Well Name: VALANCE FEDERAL 33	Well Location: T31N / R13W / SEC 33 / SESE / 36.852349 / -108.2026295	County or Parish/State: SAN JUAN / NM
Well Number: 16	Type of Well: CONVENTIONAL GAS WELL	Allottee or Tribe Name:
Lease Number: NMSF078463A	Unit or CA Name: BASIN FRUITLAND COAL	Unit or CA Number: NMNM112669, NMNM73637
US Well Number: 3004533571	Operator: HILCORP ENERGY COMPANY

Procedure Description: Hilcorp Energy is requesting approval to repair the packer on the subject well per the attached procedure.

HILCORP ENERGY COMPANY
VALANCE 33 16
PACKER REPAIR NOI PROCEDURE
API 3004533571

Action 379456

VALANCE 33 16 - PROPOSED WELLBORE SCHEMATIC

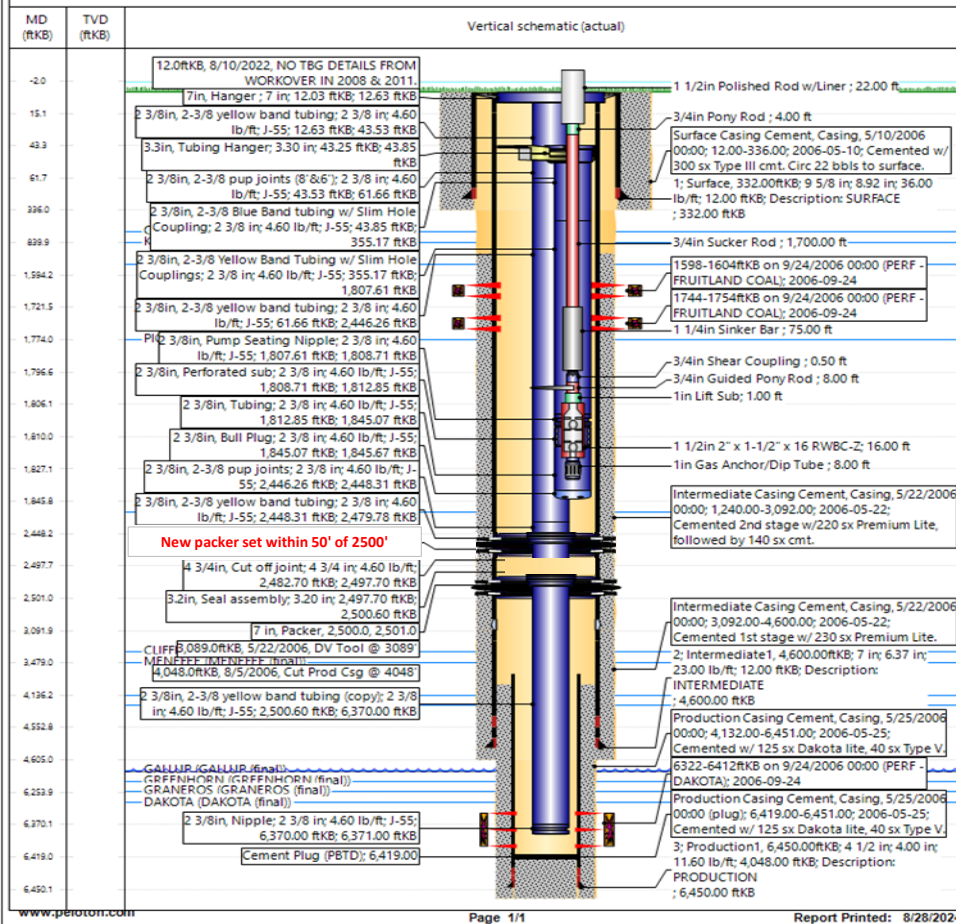
Created By	Condition	Condition Date
mkuehling	Setting a packer at 2500 is denied - Hilcorp Energy is required to remove existing packer and then replace - Monitor sting pressures daily report on subsequent - Notify NMOCD 24 hours prior to moving on - packer test required after replacement of packer.	11/4/2024
